Pointers

Fig.1 - Date Coded Speeder Spring

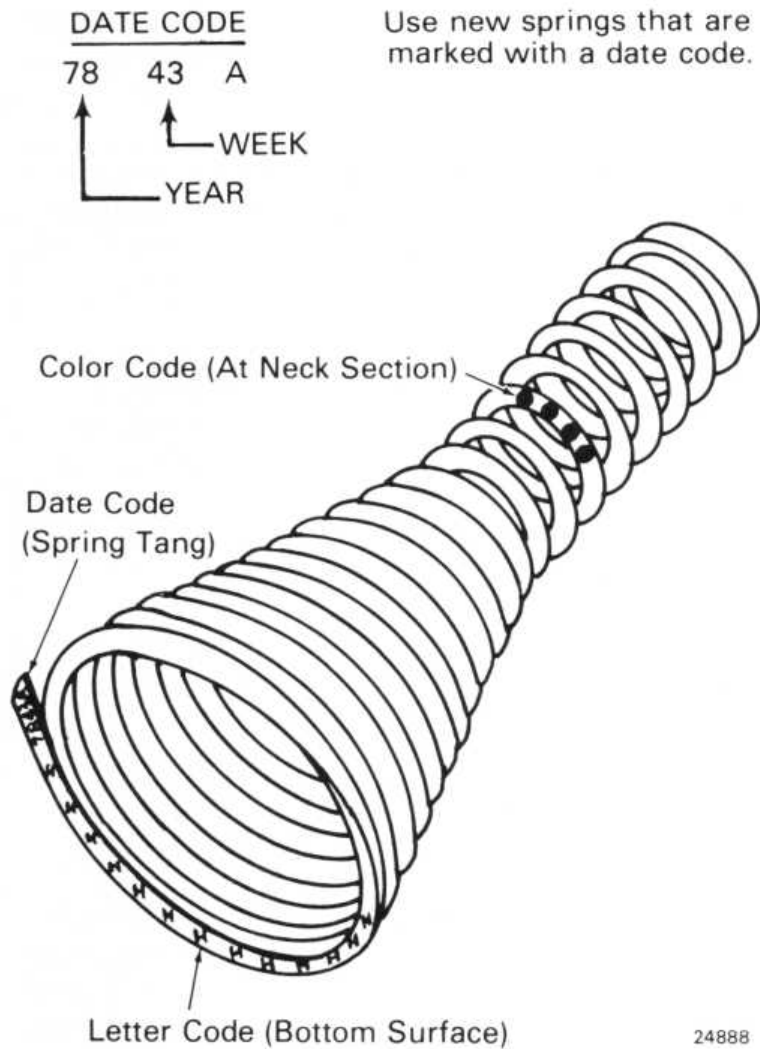
All PGR speeder springs manufactured since November 1978 have an improved cycle life and have been marked with a date code for identification purposes, Fig. 1.

At the time of governor overhaul, replace any speeder spring marked with the letter code "H" or color coded "BLUE-RED-RED-RED" that does not have a date code.

Also replace any springs having a date code of 9 years prior to time of overhaul. When the speeder spring is replaced in a governor, stamp governor nameplate in the upper right-hand corner with the letters TC and the year of the replacement; for example, if the spring was replaced during the year 1980, the nameplate should be stamped TC80.
